Errata: CS5396 Revision B

CS5396/CS5397 : 120 dB, 96 kHz Audio A/D Converter (DS229PP2 SEP '97)

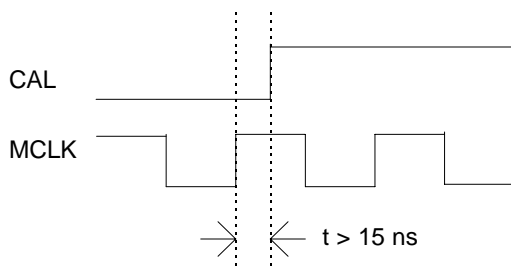
- When in slave mode, the part must be calibrated with the LRCK low as in the following diagram:

- The rising edge of the CAL pin must lag the rising edge MCLK by at least 15 ns as in the diagram below:
